A Errors in the Analysys Model

While some of the errors in the Model used by the ACCC (**the Analysys Model**) are fundamental to its design, Telstra believes that at a minimum those errors which can be corrected, should be.

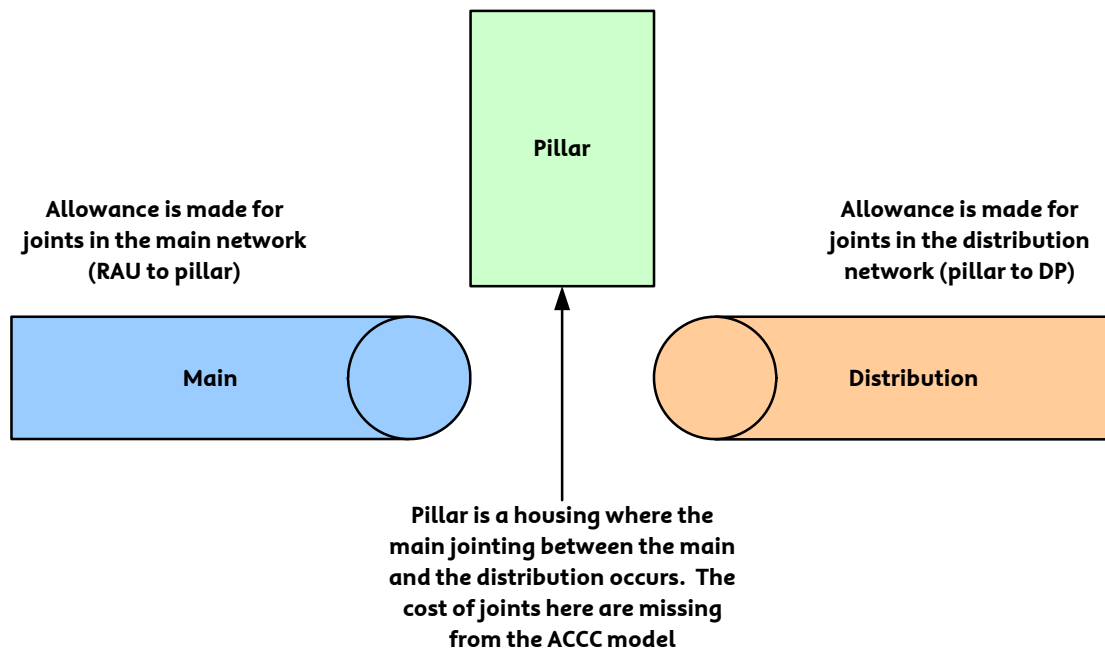
Error 1: The Analysys model does not include the joints that would be required to connect the distribution copper cables or main copper cables to pillars¹

- 1 The Analysys Model includes costs for three types of copper cable joints:
 - (a) Joints required to connect customers to the copper cable network, sized by reference to the size of the cable being used (**demand joints**);
 - (b) Joints required at points in the network to connect copper cables to each other where a distribution cable run exceeds the maximum hauling distance for copper cables (**distribution distance joints**); and
 - (c) Joints required at points in the network to connect copper cables to each other where a main cable run exceeds the maximum hauling distance for copper cables (**main distance joints**).
- 2 However, no provision is made in the Analysys Model for joints to connect each of the copper main cable and the distribution cable to a pillar or large pair gain system (**LPGS**). Below is an illustration of the joints in question.

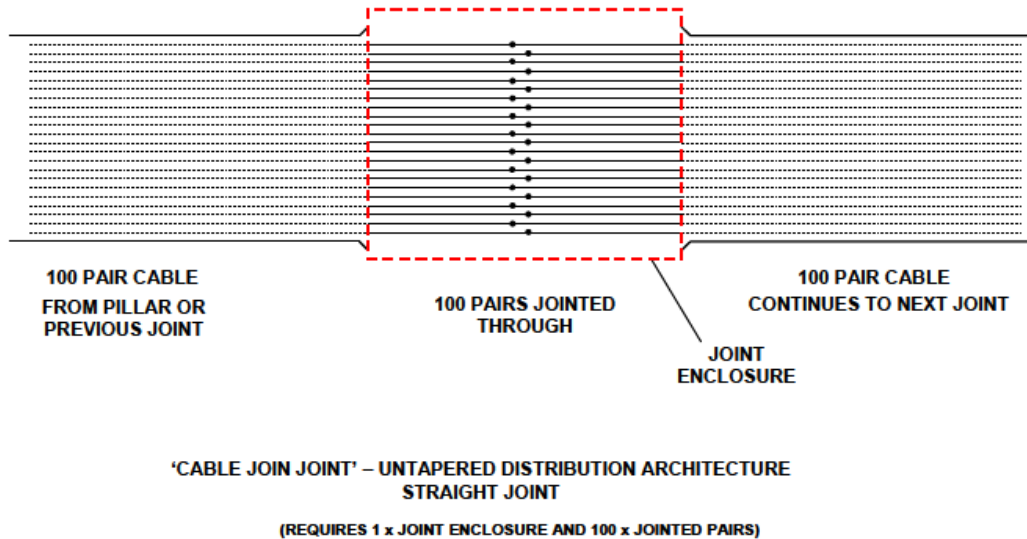
- 40 The explanation of the treatment of joints in the Analysys Model as set out in paragraphs 1-12 above also indicates that the Analysys Model does not include the costs of joints required for connecting two different gauges of copper.

- 41 The Report Regarding Customer Access Network Architecture dated 8 October 2009 by Craig Lordan (**the Lordan CAN Report, Submission Supporting Documents, Volume 1, Document 1.10**) at paragraphs 8.3-8.9 explains that joints are required to connect two cables of different gauges. The joint includes connectors for each of the wires and a housing to enclose the connectors and exposed wires. Even if the change in gauge occurs at a pillar, two joints are required to connect the two separate cables to the tails of the pillar.¹¹ Below is a diagram illustrating a joint used to connect two cables of different gauges:

- 42 In addition to a joint, if the change of gauge does not occur at a pillar, a pit or manhole is required to access the cables which are to be connected and the joint. This is explained at paragraphs 8.10 to 8.16 of the Lordan CAN Report. Pits or manholes are required to enable access to the joints for repairs or fault rectification because a high proportion of faults occur at the joints.¹² Below is a photo of a number of cables jointed together in a P9 pit built to enable access to the joints.¹³

Figure 6.3:
Structure of a DP cluster
[Source: Analysys]

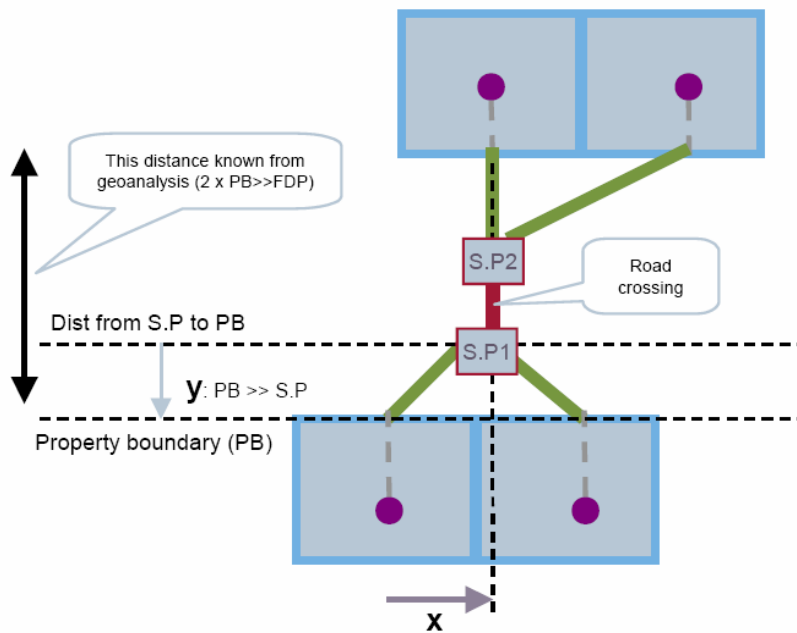
- 76 In the diagram above, the Serving Pit Architecture consists of S.P1; S.P2, the green lines and the red line. The ACCC/Analysys design change to introduce the Serving Pit Architecture modified the way distances from the property boundary to the serving pit are measured in the model.

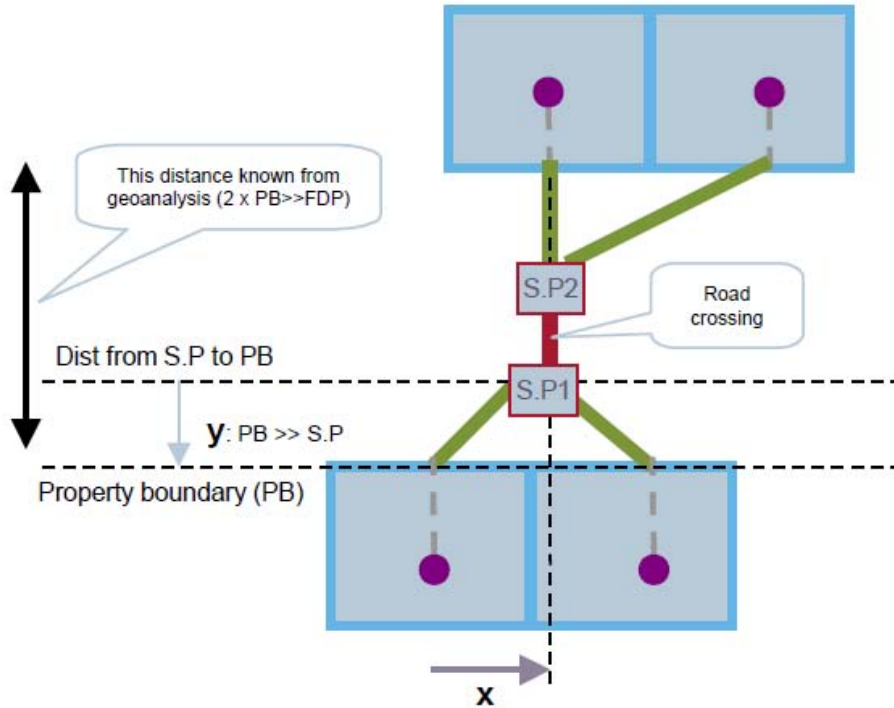
- 99 Below is a diagram of the distribution pit architecture used in the Analysys Model. The network is built on one side of the road with a distribution pit serving from one to four customer locations. The model provides for trenching and conduit for the cable from the distribution pit to the other side of the road but does not provision sufficient length of cable sheath to serve the homes on the opposite side.

Figure 20

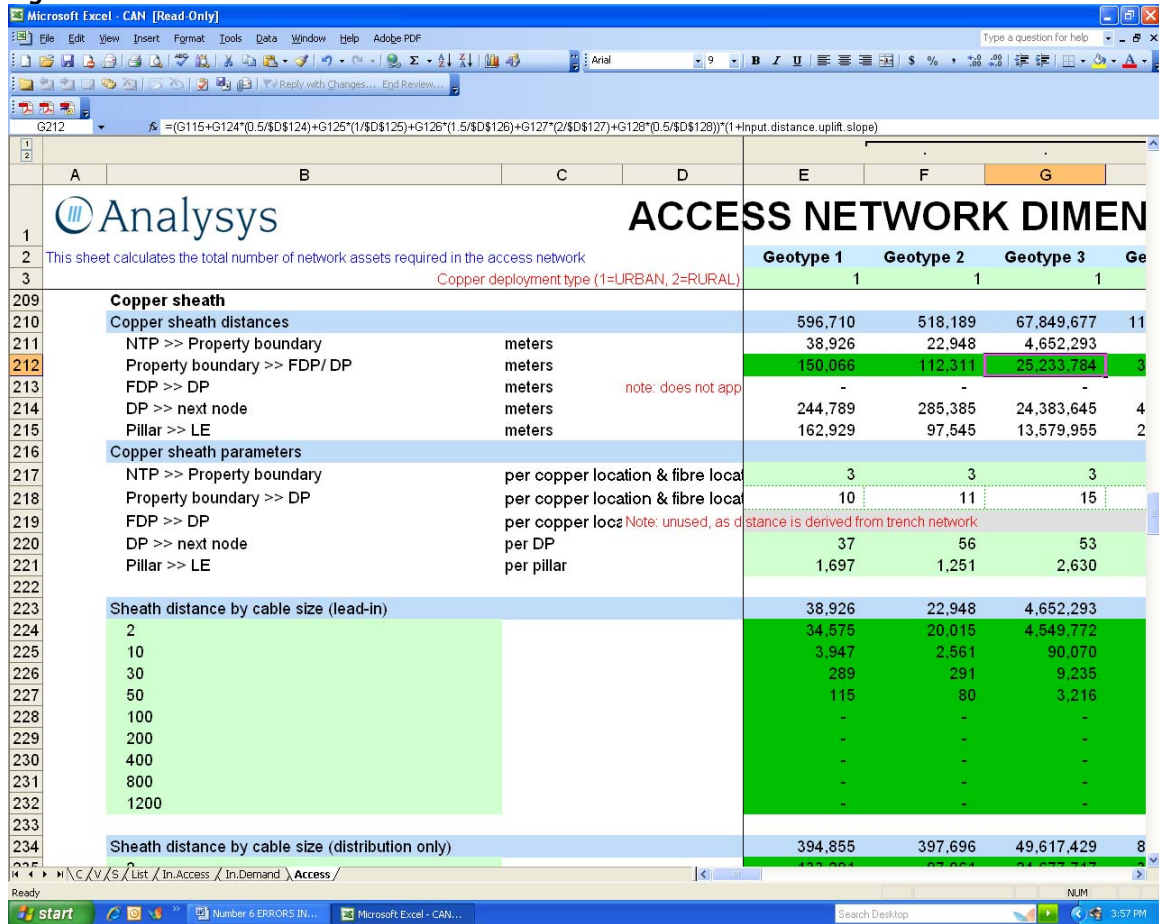
122 G115 remains unchanged from the original formula and is equal to the sheath distance necessary to serve property boundary to serving pit. The remainder of the formula is the corrected formula for road crossing sheath. It is the sum of the product of the road crossing trench distances for the various sizes of DP clusters (plus isolated FDPs) times the (Average number of copper sheaths per DP cluster) / (Average number of road crossings per DP cluster).

119 The model was corrected (see Figure 20) as follows. The original formula for LINE 212G (for geotype 3) in the model was:

$$=(G115+G124*(0.5/\$D\$124)+G125*(1/\$D\$125)+G126*(1.5/\$D\$126)+G127*(2/\$D\$127)+G128*(0.5/\$D\$128))*(1+Input.distance.uplift.slope)$$

Figure 22

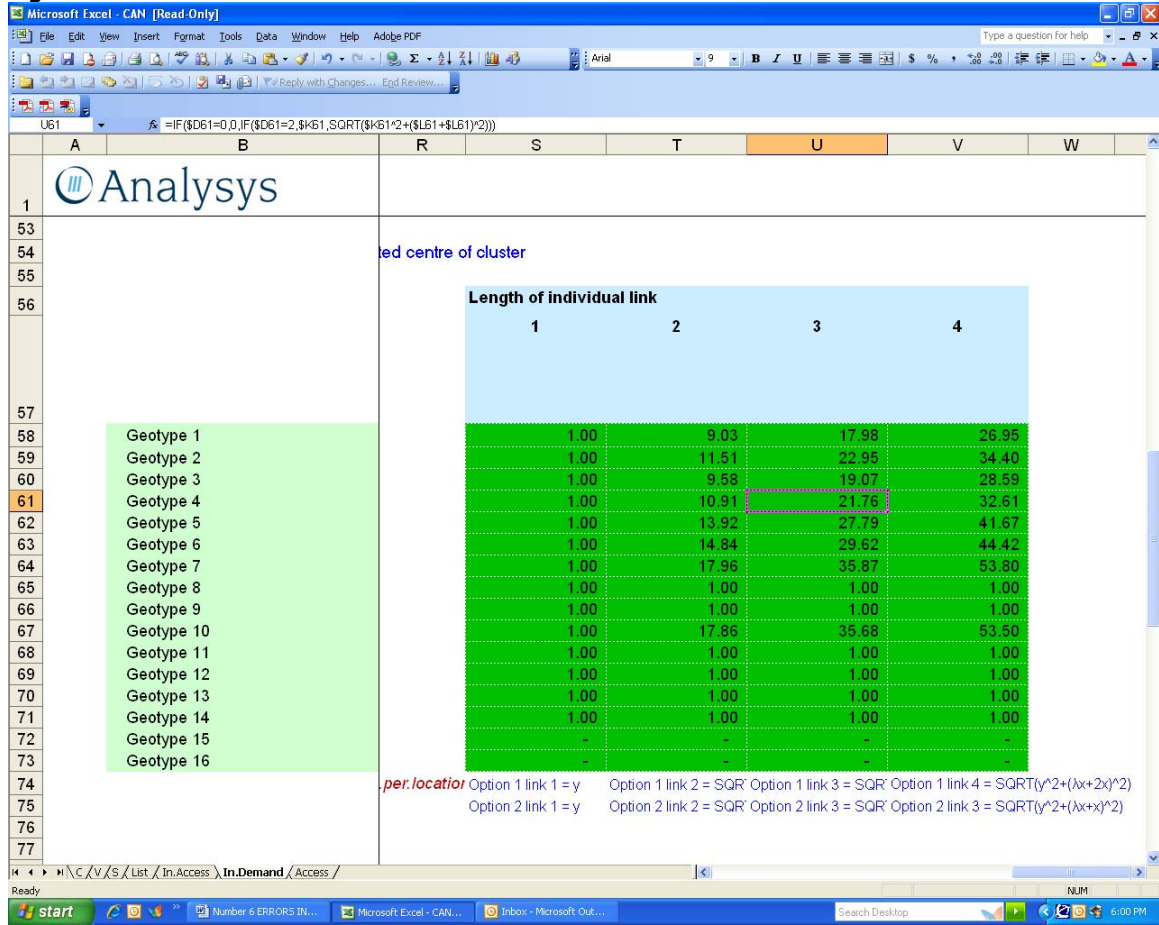
137 The net result of the changes is that the DP/serving pit location remains where it is placed by geanalysis (N55 always equals 1) and the property boundary width remains as measured by geanalysis (line 76N - 76Q always equals 100%).

- 135 As can be seen the following changes have been made to the original formula in the corrected version:
- (a) no change has been made to the first part of the formula related to \$D61;
 - (b) the If Statement related to N55 has been removed and only the N55=1 version of the formula has been retained;
 - (c) the (N55 does not equal 1) option has been removed; and
 - (d) P\$76 has been removed.
- 136 The original formula, with the portions that have been removed highlighted in yellow is reproduced below.

=IF(\$D61=0,0,IF(\$D61=2,\$K61,IF(\$N\$55=1,SQRT(\$K61^2+(\$L61*\$P\$76+\$L61)^2),SQRT(\$K61^2+(\$L61*\$P\$76)^2))))

Figure 56

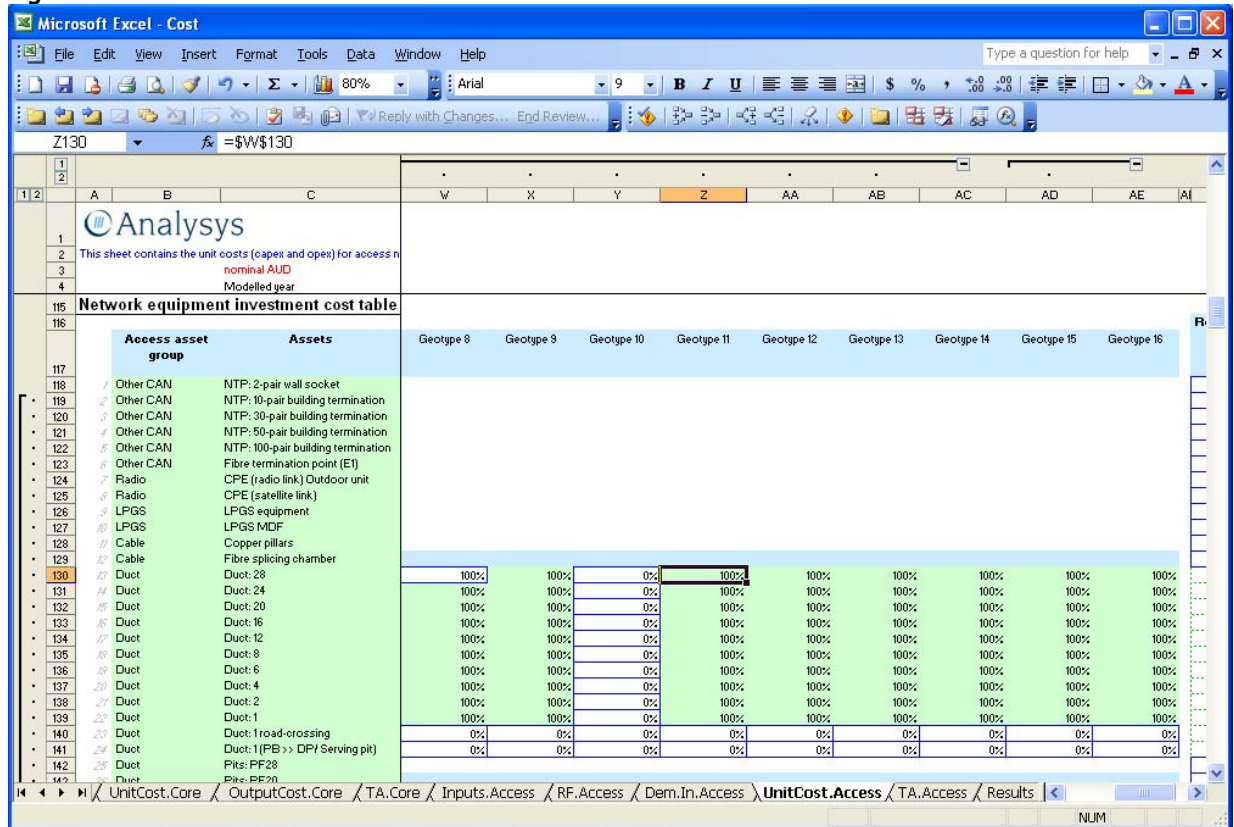
- 388 The Analysys Model assumes that cables that are greater than 100 pair in size can be ploughed. They cannot. The reasons for this are set out at section 9 of the Jordan CAN Report.
- 389 Because cables greater than 100 pair cannot be ploughed they need to be put in trenches. The Analysys Model therefore needs to be adjusted so that it no longer assumes ploughing for cables greater than 100 pair in size.
- 390 The illustration of the Analysys Model at Figure 56 below, shows how ploughing enters into the cost calculation. 100% of duct (not cable) is assumed to be ploughed in geotypes 8, 9 and 11 to 16. It is odd that the Analysys Model does not allow the user to enter in ploughing of cable, but rather enters the ploughing of duct. Duct is inflexible 100mm PVC pipe and cannot be ploughed.
